**RE: CORRECTION: APPROVAL WITH MODIFICATIONS
PROPOSED WELL DESIGN FOR REGIONAL AQUIFER MONITORING WELL R-76
LOS ALAMOS NATIONAL LABORATORY
EPA ID#NM0890010515
LANL-22-019**

The New Mexico Environment Department (NMED) has received the United States Department of Energy (DOE) *Proposed Well Design for Regional Aquifer Monitoring Well R-76* (Well Design) dated and received on December 22, 2023 and referenced as EM2023-0861.

Table 1: Selected photographs of the Cerros del Rio (CDR) and Puye contact chip record at 8x magnification.

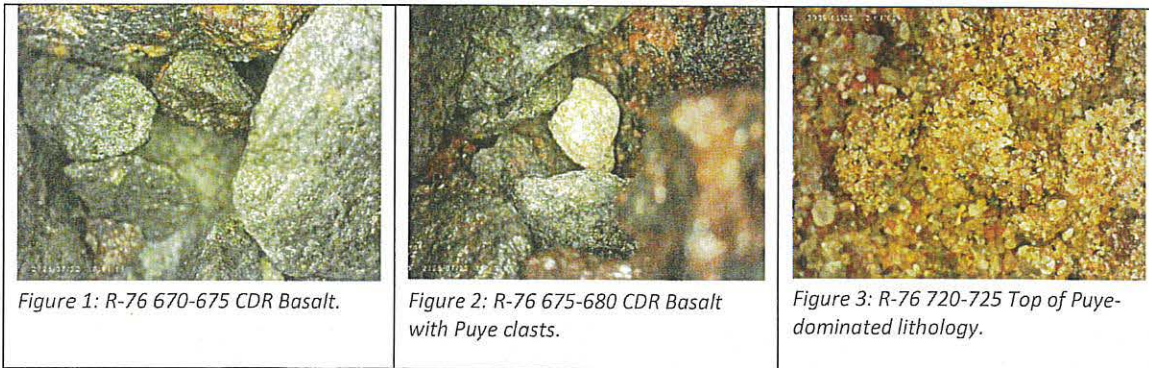
DOE describes the lithology at the contact of Cerros del Rio Basalt and Puye as Puye at first contact (675-680 ft bgs). At this location NMED's evaluation demonstrates that the neutron count remains high and a composition of approximately 80% Basalt and 20% Puye (Table 1). NMED advises that the change of formation should be called when the Puye indicator clast dominates the sample, rather than when it first appears in trace amounts. From NMED evaluation, it is not apparent until reaching depths of 720-725 ft bgs that the Puye clast count exceeds Basalt, and this corresponds with a drop in the neutron count indicating sedimentary porosities.

It may also be beneficial to designate a contact lithology for this interval, given that thin basalt flows on cold clastics would likely result in different hydrogeological characteristics than either a thick basalt flow or the Puye beneath it.

Table 2: Selected photographs of the Puye Pumicious and Miocene Pumicious contact at 8x magnification.

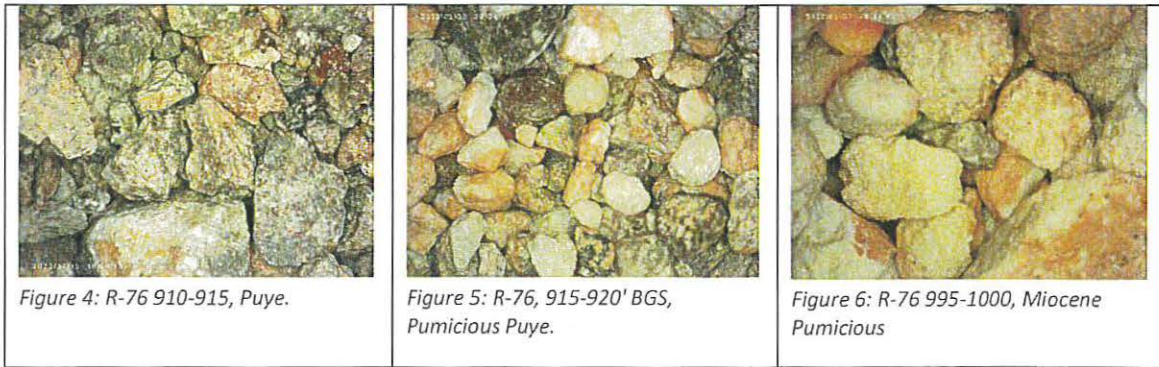
NMED's evaluation, based on clast percentages and the presence of tan fines (silt and clay) that remains adhering to the surface of clasts, also logs Pumicious Puye from 915-995 ft bgs and Miocene Pumicious from 995-1000 ft bgs. The Miocene Pumicious formation is composed of nearly pure pumice and is only 6-10 feet thick at the reference outcrop. The overlying Pumicious Puye includes Puye with sand and fines as matrix to the pumice clasts and is 60-70 feet thick at the reference bed (Table 2). This is where the loss of fines in the sample method is important because it may change the apparent percentage of the remaining clasts.

Table 3: Typic clasts and peds from the Pumicious units at the base of the Puye formation.

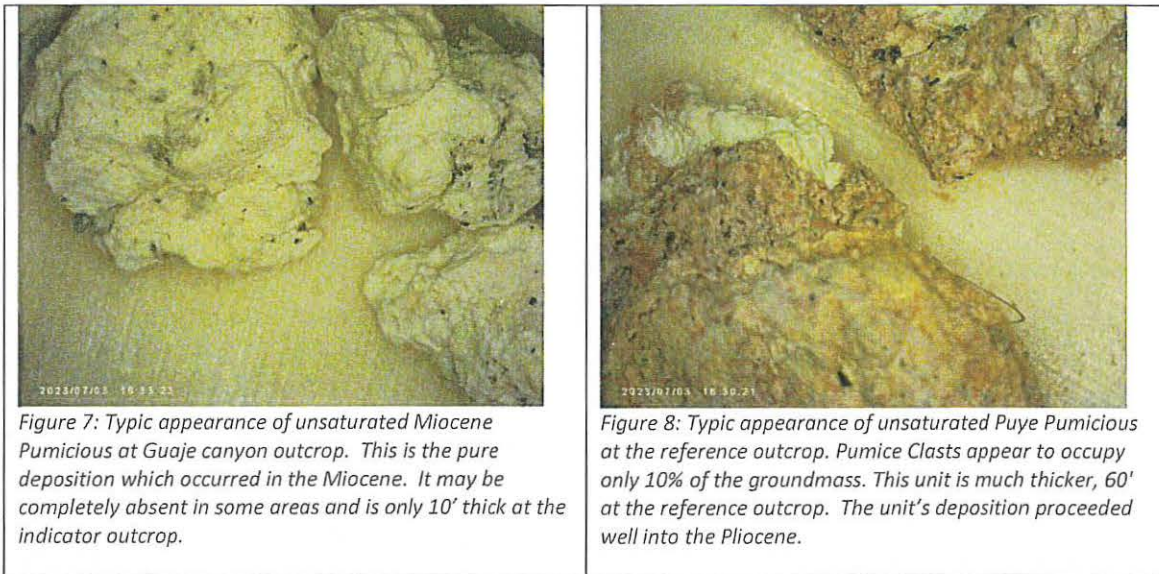
Miocene Pumicious (Table 3) is a thin indicator bed suggesting close proximity to the Chamita and extreme caution is required during drilling operations to maintain control over inter-aquifer flows which may occur under confined conditions. The means of delineating the boundaries of these units is important, and NMED would like to engage in dialogue regarding why EM-LA did not map any Pumicious Puye at this location.

NMED supports accurate determination of the difference between Pumicious Puye and Miocene Pumicious units, reflecting known distribution of the units and upholding safe exploration of contamination in the Chamita formation.
